FINDING OF NO SIGNIFICANT IMPACT: INTERIM STORAGE OF PLUTONIUM
COMPONENTS AT THE PANTEX PLANT, AMARILLO, TEXAS

ACTION: Finding of No Significant Impact for the Interim Storage of
Plutonium Components at the Pantex Plant.

**ENVIRONMENTAL ASSESSMENT
FOR
INTERIM STORAGE OF
PLUTONIUM COMPONENTS AT PANTEX
AND
DEPARTMENT OF ENERGY
RESPONSE TO COMMENTS ON
THE PRE-APPROVAL ENVIRONMENTAL
ASSESSMENT
AND
THE REVISED PRE-APPROVAL
ENVIRONMENTAL ASSESSMENT AND
PUBLIC MEETING**

VOLUME I, SECTION II DEPARTMENT OF ENERGY RESPONSE TO COMMENTS ON THE PRE-APPROVAL ENVIRONMENTAL ASSESSMENT RECEIVED FROM THE STATE OF TEXAS

Figure 2.1 Near-Term Projected Storage Capacity Requirements

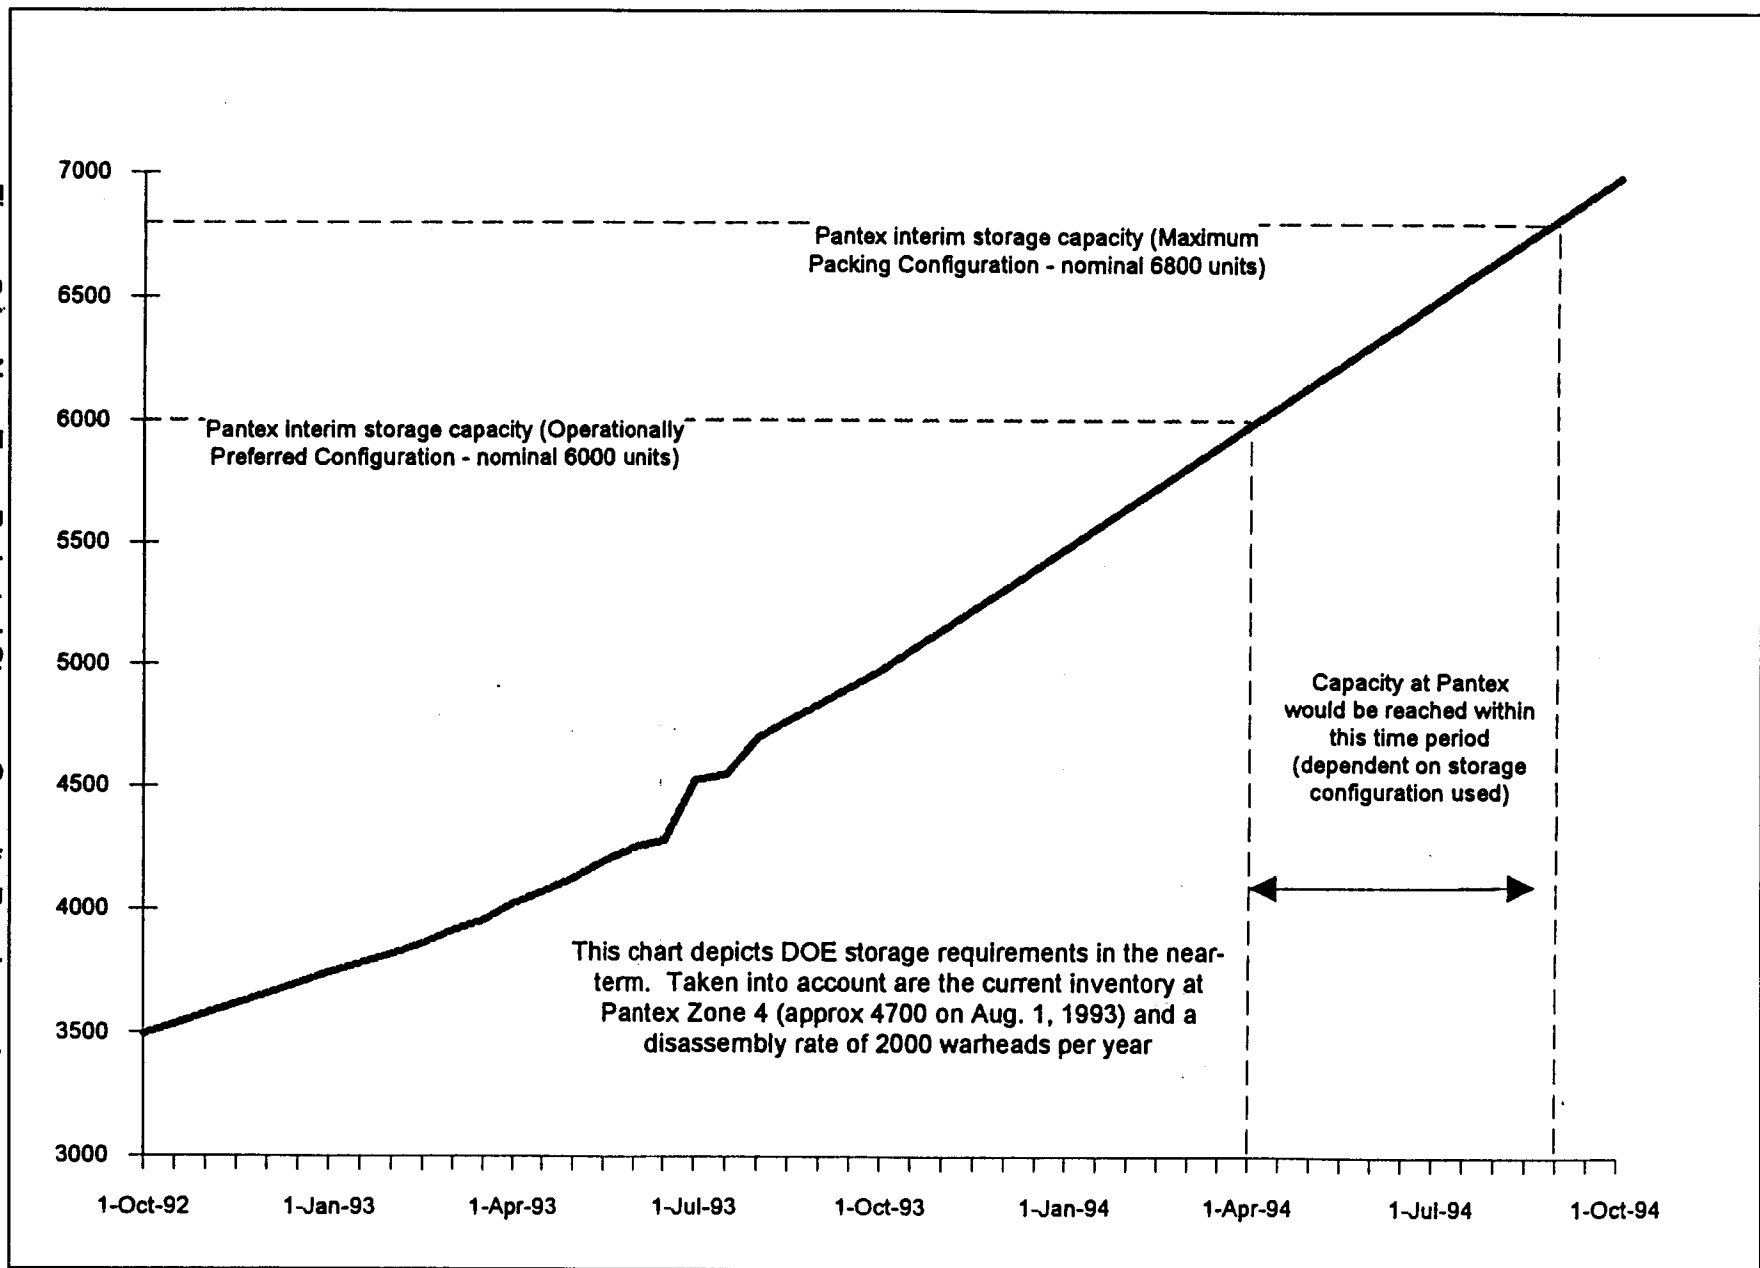
6. Page 2-2. Figure 2.1 indicates that in the three years since RFP stopped processing pits (December 1989 to 4th Quarter 1992), Pantex has accumulated between 3,300 and 3,800 pits. How many are actually stored at Pantex? Have any pits been shipped off-site since December 1989? If so, how many and to what location(s)? (See also: issues raised in comments about page 1-2.)

Figure 2.1 of the Environmental Assessment presents the actual data for the starting pit inventory at the Pantex Plant. As of November 1, 1993, the total number of pits stored at the Pantex Plant is approximately 5,200. Based on this figure, it is expected that storage capacity will likely be reached in the first quarter of 1994.

Figure 3.2 - Modified-Richmond Magazine Vertical Single-Layer Configuration
(Operationally Preferred)

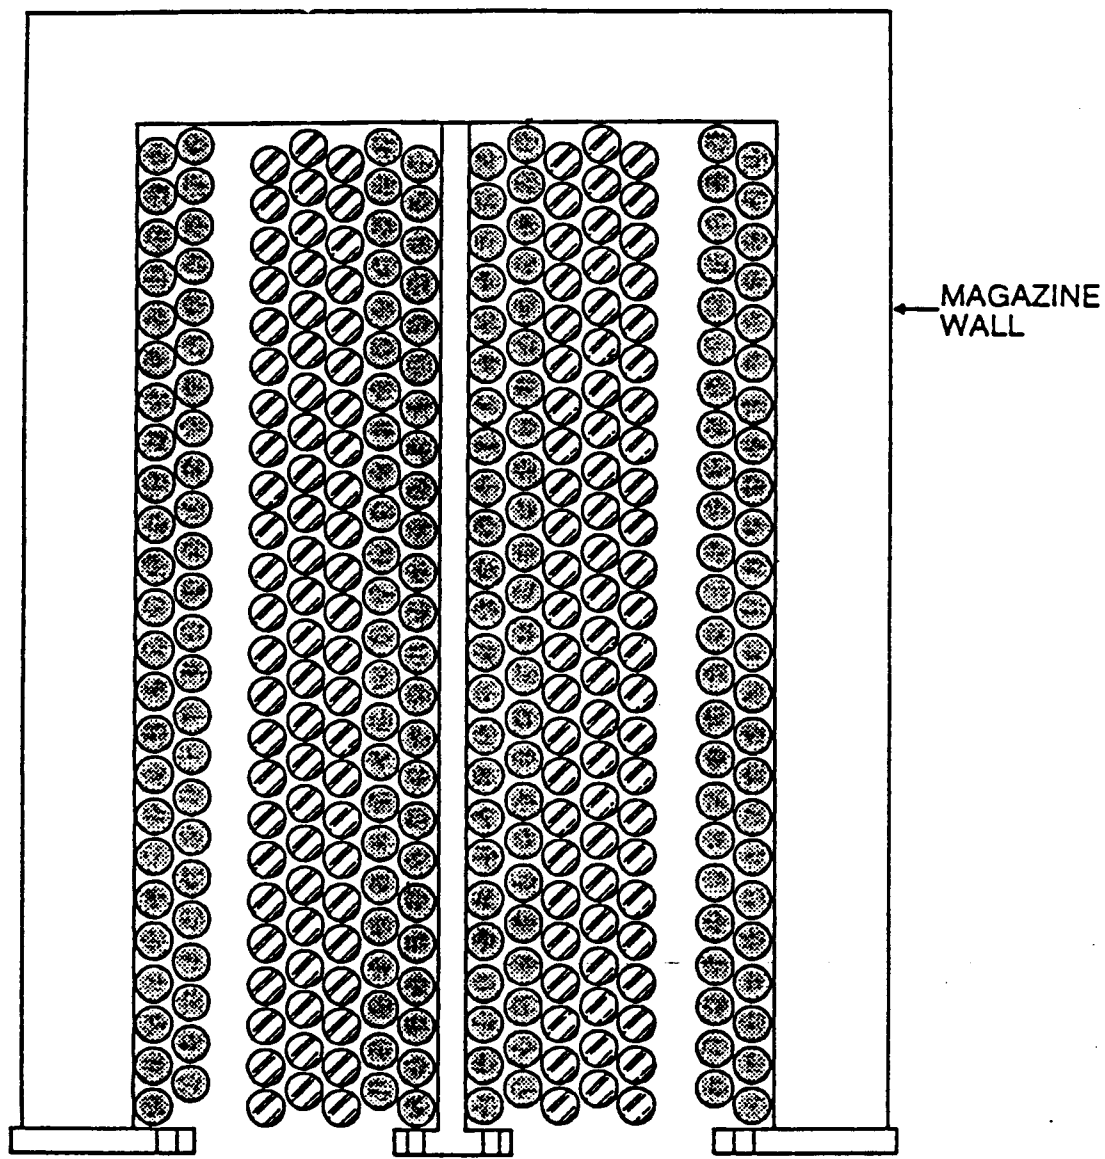
"Individual pit containers could rest on casters rather than on the concrete floor of magazines," but Figure 3.2 (page 3-4) says that having six rows of pits on casters is "operationally preferred." The EA must provide an analysis of why such a configuration is operationally preferred. For each configuration, the EA must provide an analysis of how inspections would be done, including how much movement of pit containers would be necessary, how two workers could ensure that each container was returned to its assigned location, how much time the configuration takes to load and unload and the calculated exposures. For containers on casters, the EA must describe the operational experience with casters, how frequently casters break or containers fall off.

Figure 3.4 - Steel Arch Construction Magazine Proposed Horizontal Palletized Multiple Stacking Configuration

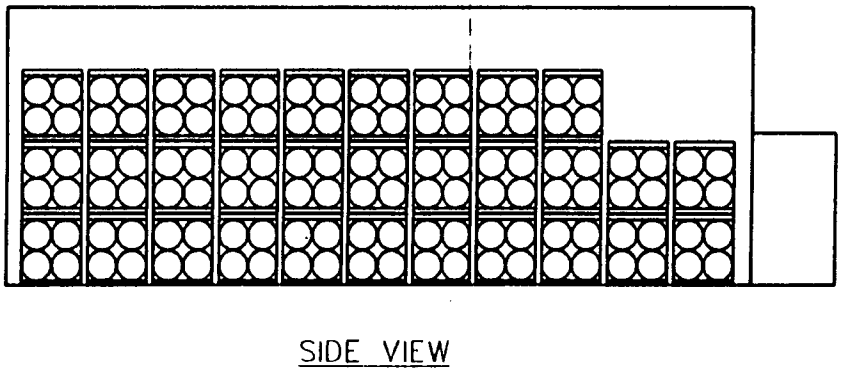
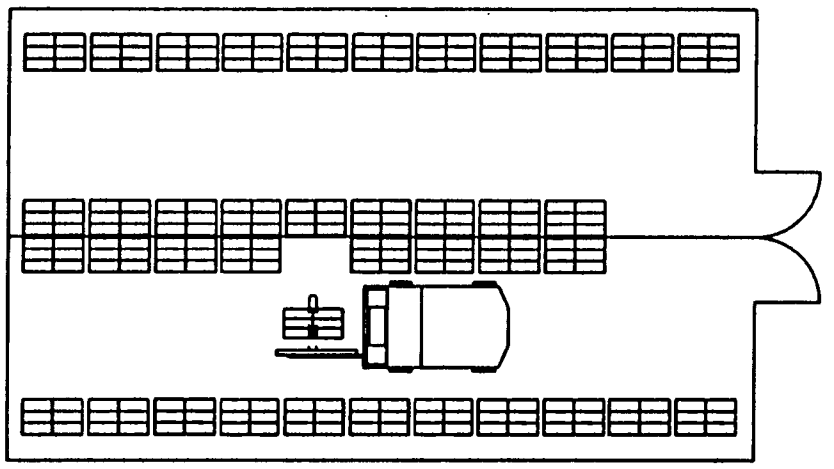
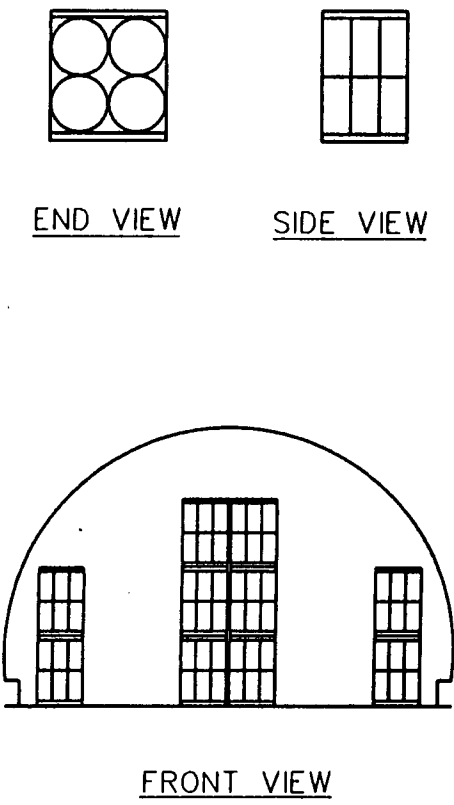
Question: Figure 3.4 exhibits 460 pit capacity for horizontal palletized multiple stacking. Which number is the capacity to be used?

For palletized multiple stacking, the EA must describe how frequently the pallets would be changed, the history of damage and breaking of the pallets, accident scenarios including possible releases when pallets break and containers are dropped. It must describe the structural integrity of each pit container, its design specifications including weight-bearing ability, actual history of containers supporting triple stacking (as shown in Figure 3.4).

Pits in each magazine type can be stacked in the single-layer vertical or the horizontal palletized multiple stacking configuration. For the Modified-Richmond magazine, the horizontal palletized multiple stacking configuration is 440 (Figure 3.3) and the single-layer vertical configuration is 378 (Figure 3.5). For the Steel Arch Construction magazine, the horizontal palletized multiple stacking configuration is 392 (Figure 3.4) and the single-layer vertical configuration is 384 (Figure 3.6). Figure 3.4 in the Environmental Assessment exhibits a center section that consists of two rows of nine sets stacked three high with four pits in each set for a total of 216 pits. There is also a left and a right row of 11 sets stacked two high with four pits in each set for a total of 176 pits. The combined total for Figure 3.4 is 392 pits. The Steel Arch Construction magazine shown in Figure 3.6 is capable of having 406 containers but the operational limits is set to 384 containers, which will allow for some space in the room for movement of the containers.

**Figure 3.5 - Modified-Richmond Magazine Vertical Single-Layer Configuration (Bounding)
(All Containers on Casters)**

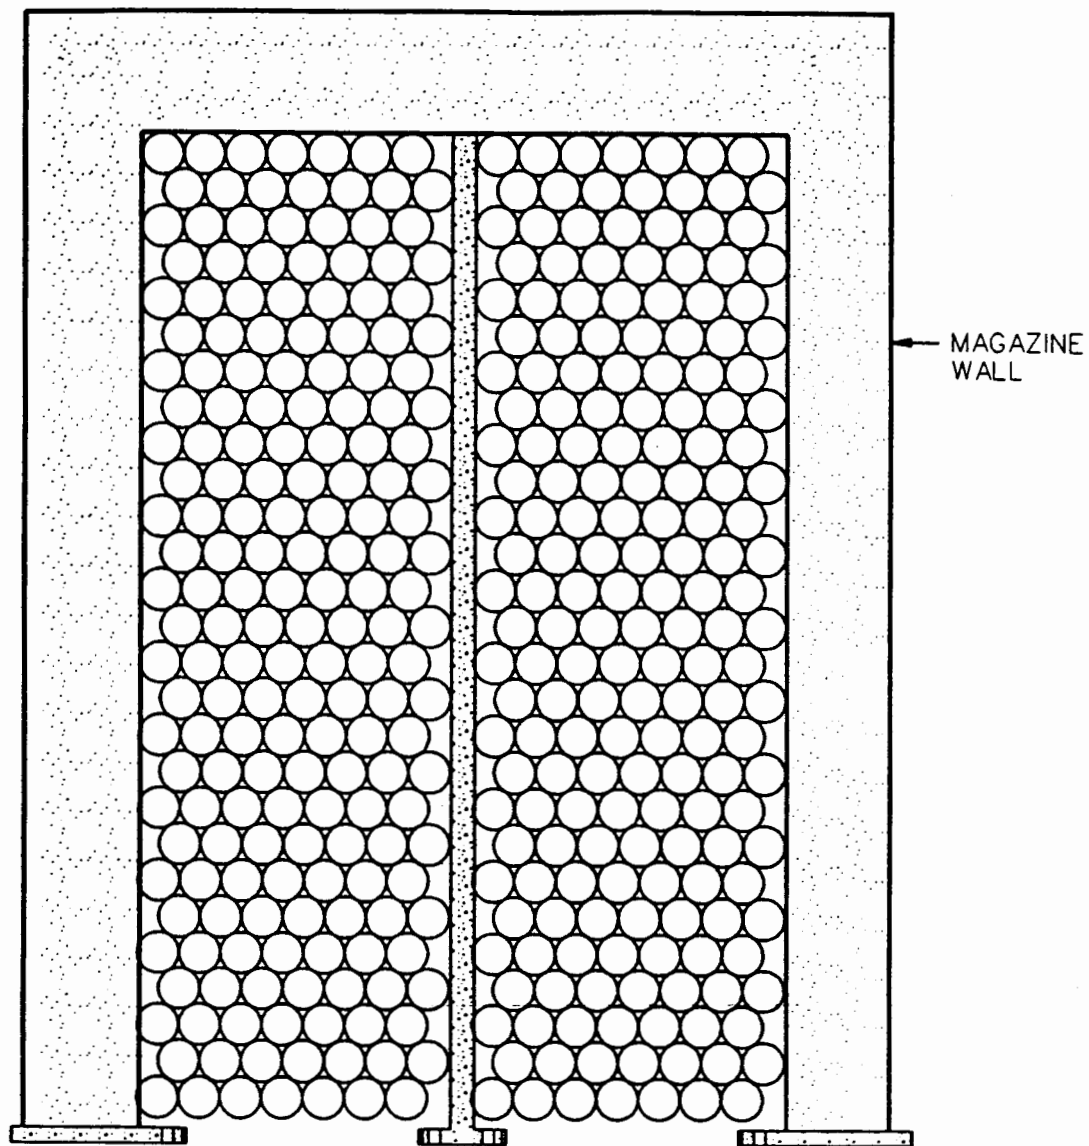
No where in the draft EA does DOE commit to not using the single-layer configurations depicted in Figures 3.5 and 3.6, both described as "(Bounding)," yet both depicting and adding up to the maximum packing arrangement. However, on page 4-1 the discussion warns of maximum packing, and states: "Actual best management practice to facilitate required safeguards and security activities and reduce worker exposure to radiation could dictate use of other storage configurations that would provide less pit storage capacity."

The close pack vertical configuration shown in Figure 3.5 of the Environmental Assessment is for 378 containers in a solid arrangement. If all 18 Modified-Richmond magazines were configured like this, the total capacity would be 6,804 (the 6,800 maximum packing configuration). The operationally preferred configuration shown in Figure 3.2 of the Environmental Assessment is for 336 containers in a solid arrangement with an aisle on each side of the magazine. If all 18 Modified-Richmond magazines were configured like this, the total capacity would be 6048 (the nominal 6000 pits). The operational preferred configuration in Figure 3.2 facilitates required safeguards and security activities and reduces worker exposure to radiation by providing an aisle down each side of the magazine.

**Figure 3.6 - Steel Arch Construction Magazine Vertical Single-Layer Configuration
(Bounding) (All Containers on Casters)**

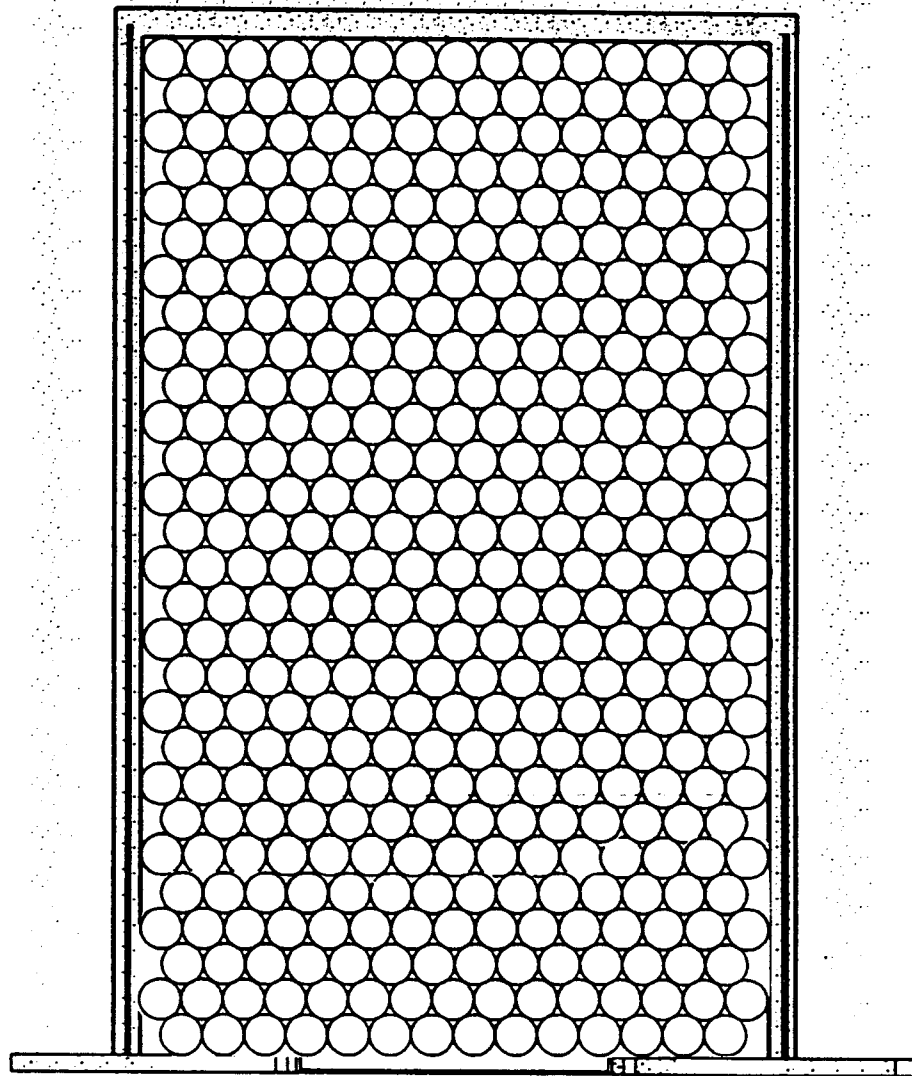
- no scale is given
- the containers are not specified (AL-R8 or others)
- the figures are inconsistent with the narrative. For example, Figure 3-6 shows the bounding single-layer configuration in the SAC magazines is 420 containers, whereas page 3-1, footnote 2 says maximum packed capacity is 406 pits. Figure 3.2 shows 336 pits as the "operationally preferred" configuration for Modified-Richmond magazines, whereas page 3-1 says that storage would increase from existing 378 pits to 440 pits. In contrast Figure 3.5 shows 378 pits as the "bounding" configuration.

On the third point, Figure 3.6 of the Environmental Assessment shows the bounding single layer configuration of 406 containers, which is consistent with the maximum packed capacity mentioned in the second footnote of Section 3.0. Figure 3.2 shows 336 pits as the operationally preferred configuration for vertical single-layer storage; whereas Section 3.0 explains that the maximum or bounding limits would increase from 378 pits (bounding vertical single-layer storage configuration) to 440 in the horizontal palletized multiple stacking configuration. Table G-1 clarifies these issues.

Figure 5.8 - Average Annual Wind Rose for Pantex Area

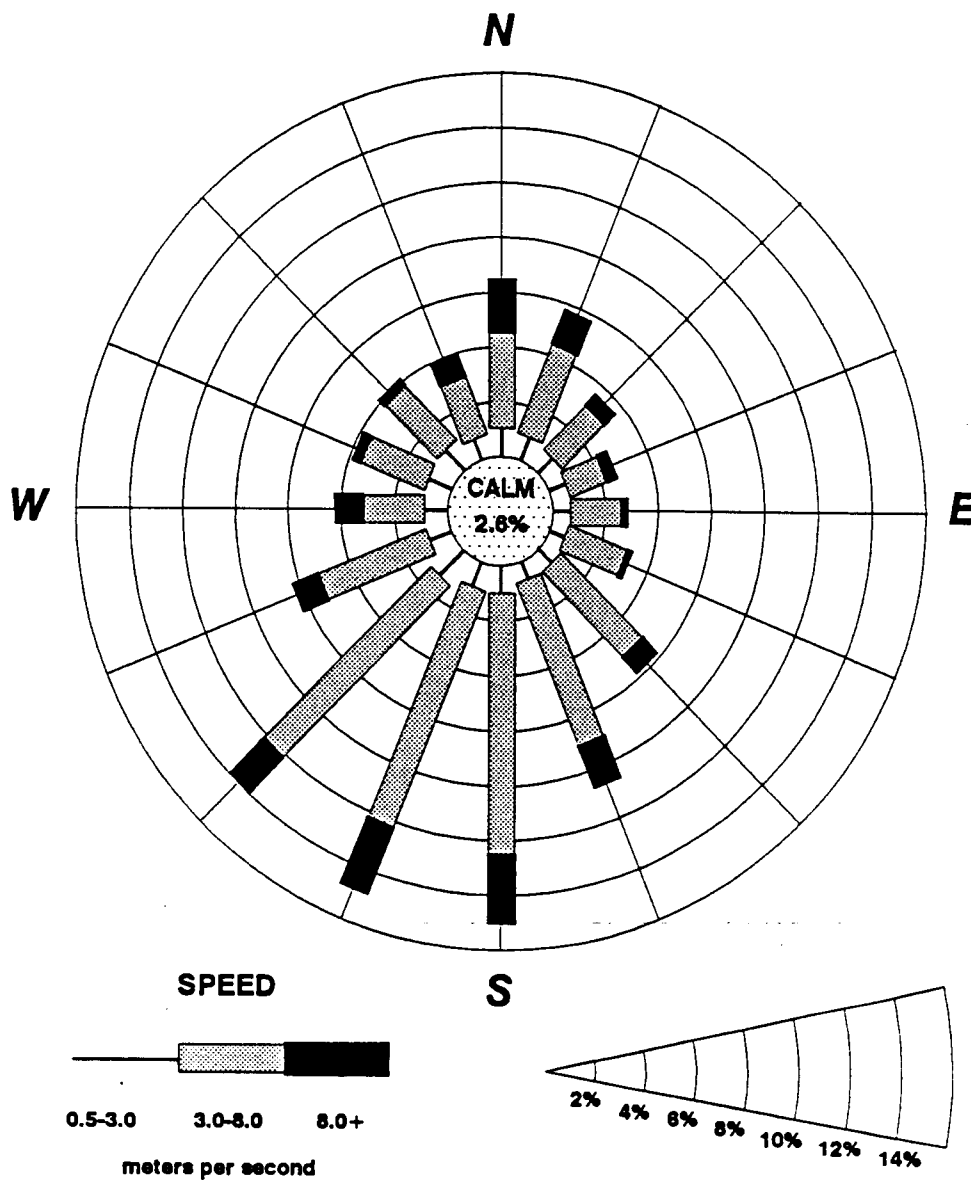
I question the accuracy of the average annual wind rose, located on page 5-10, Figure 5.8, in the report. I found no reference cited for the data in the figure. An error or misrepresentation of such data can result in inappropriately placed air quality samplers, and consequently, errors in air quality measurements.

Figure 5.8, which appears on Page 3-3 of the 1983 Final Environmental Impact Statement, Pantex Plant Site (DOE/EIS-0098), represents the average annual wind rose for 1955 through 1964, based on data obtained from the National Weather Service Station located at the Amarillo International Airport in Amarillo, Texas. This 10 year wind rose is similar to wind roses from recent years and is considered to be accurate.
